# MARTIN COUNTY, FLORIDA DEVELOPMENT REVIEW

## STAFF REPORT

## **I-95 RIVERSIDE PUD PHASE IV PLAT A/K/A Pulte I-95 (Camellia)**

This is a request by HJA Design Studio, LLC, on behalf of Pulte Home Company, LLC, for approval of the 95 Riverside PUD Phase IV Plat. The Plat is to be consistent with the Phase IV Final Site Plan which contains 98 single-family townhomes on an approximately 12.40-acre site. The 95 Riverside PUD is located on the north side of SW Kanner Hwy / SR 76, on SW Lost River Road, approximately 0.17 miles east of the I-95 interchange in Stuart. Included is a request for a Certificate of Public Facilities Exemption.

# CAMELLIA P.U.D.

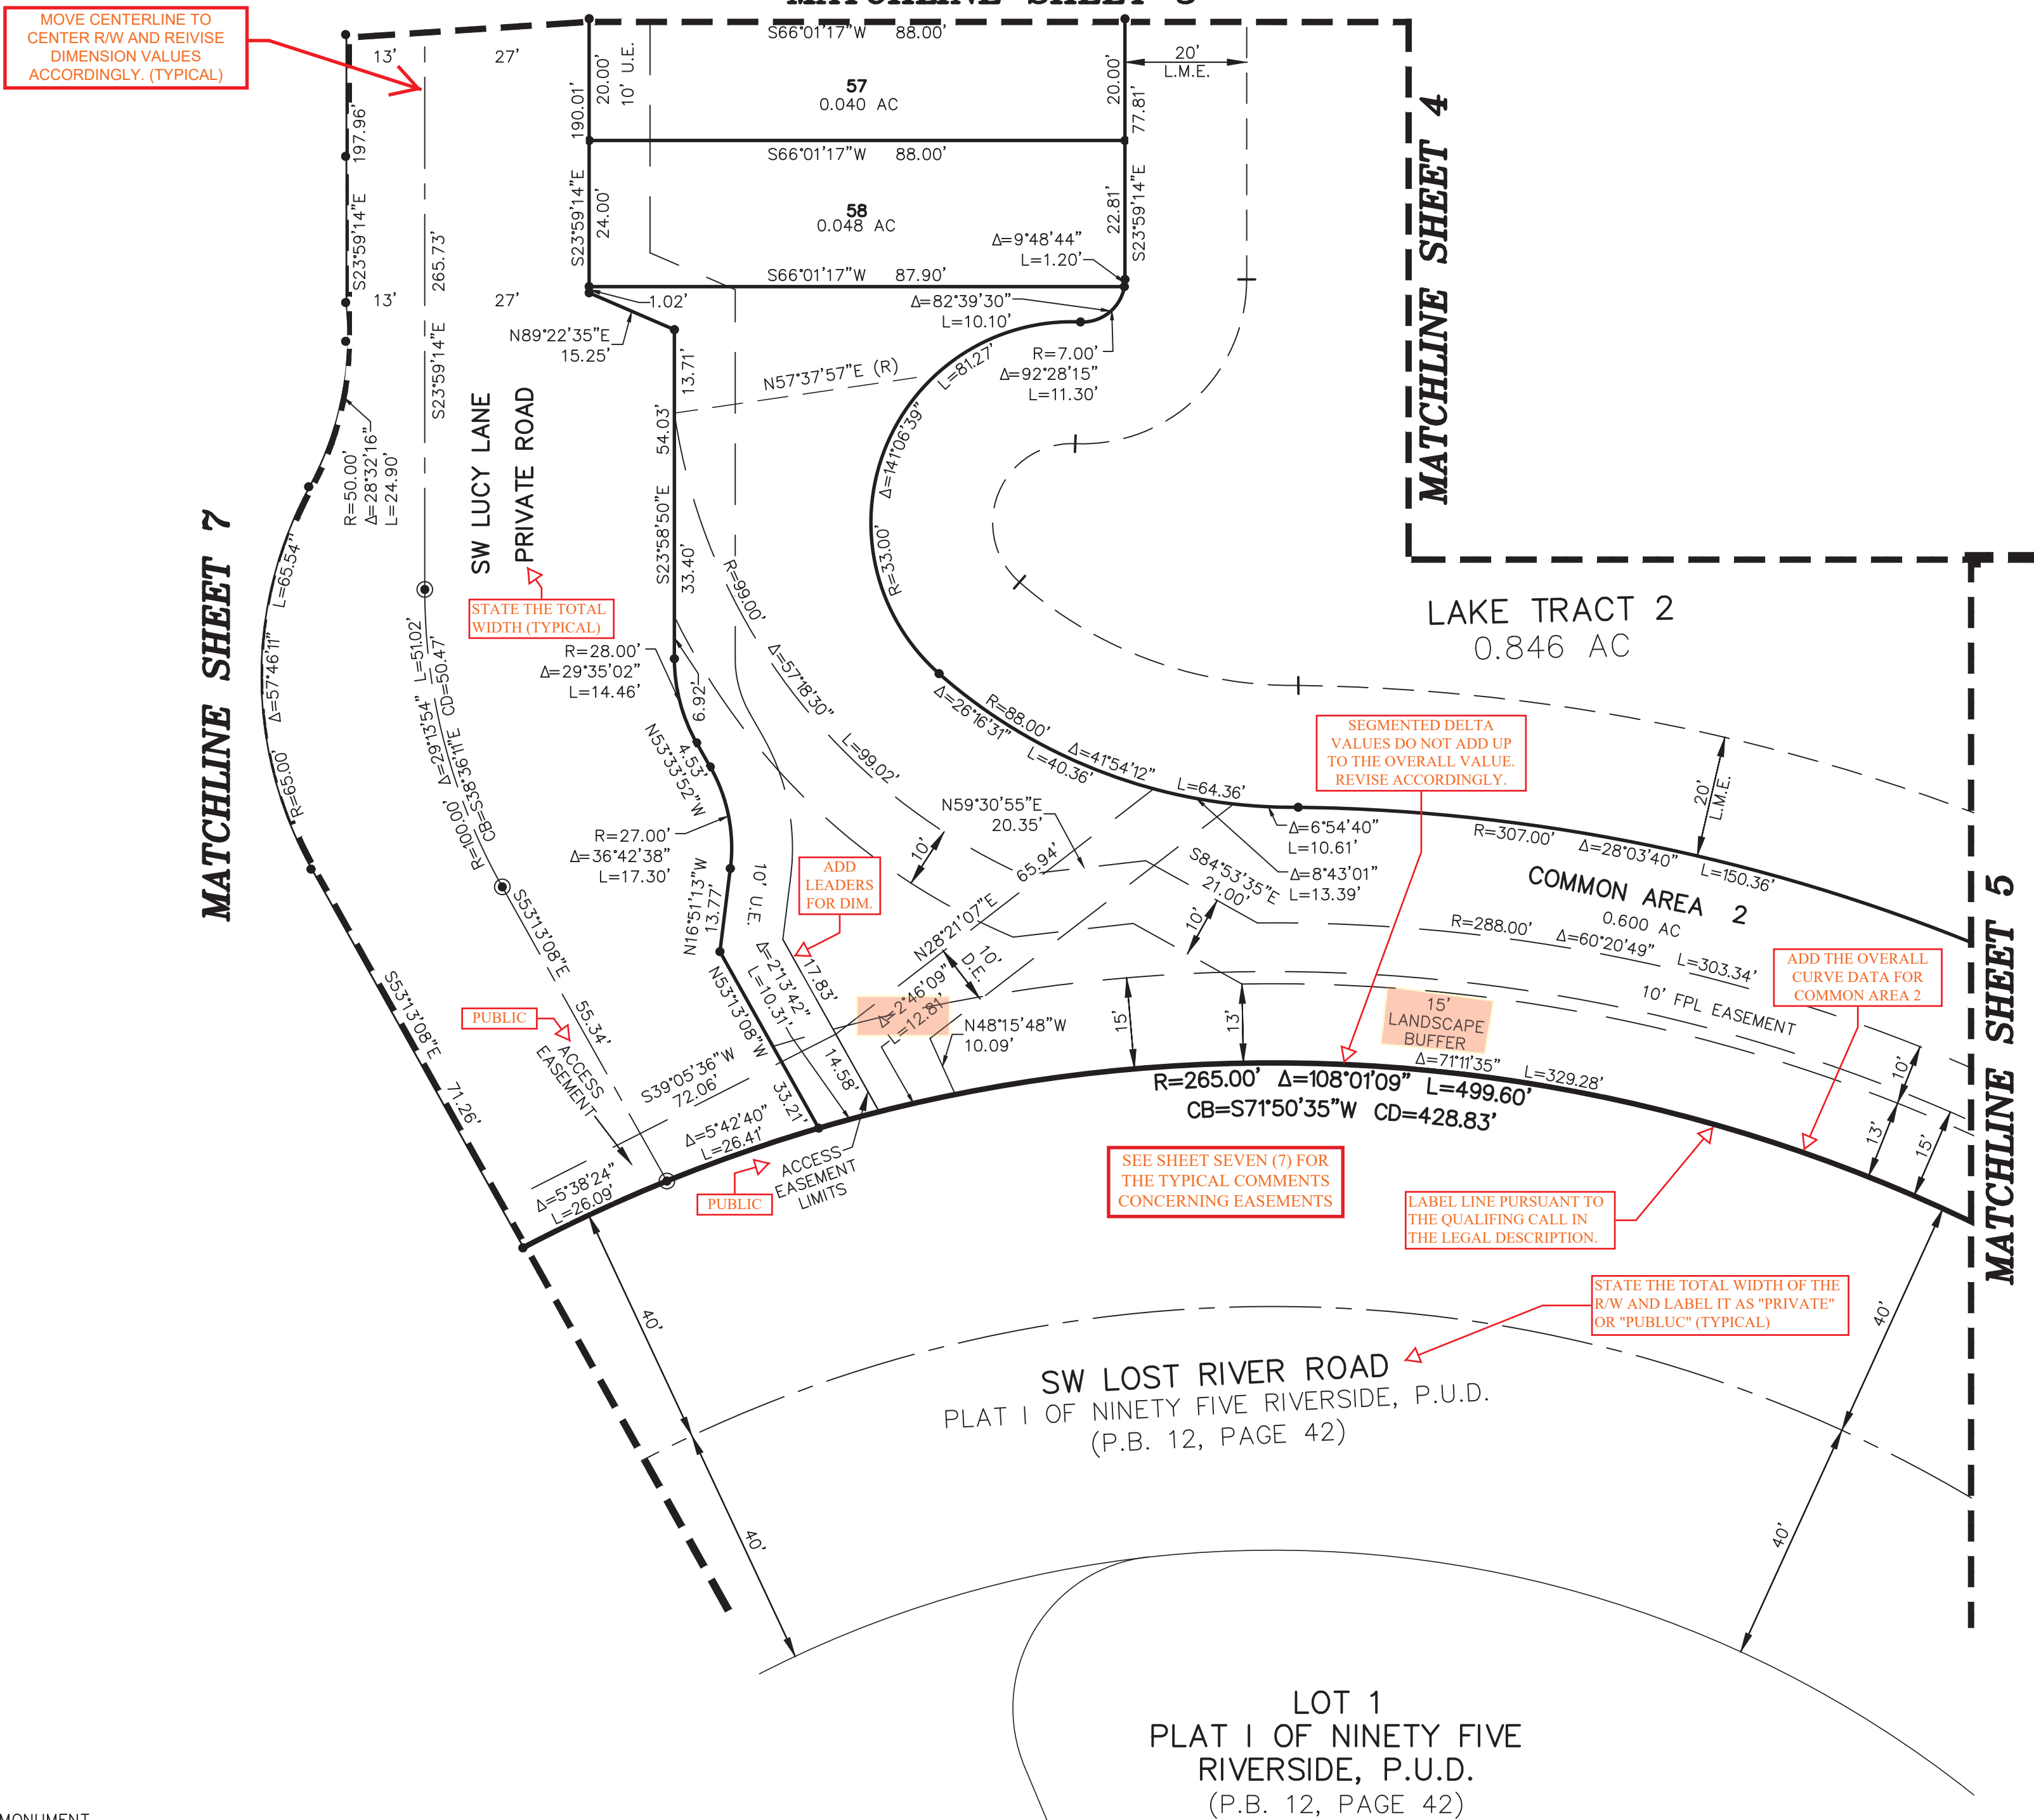
THERE ARE EASEMENTS SHOWN ON THE PLAT THAT ARE NOT DEPICTED ON THE SITE PLAN. CORRECT THE INCONSISTENCIES WITH SAID PLAN AND/OR VISE VERSA. (TYPICAL)
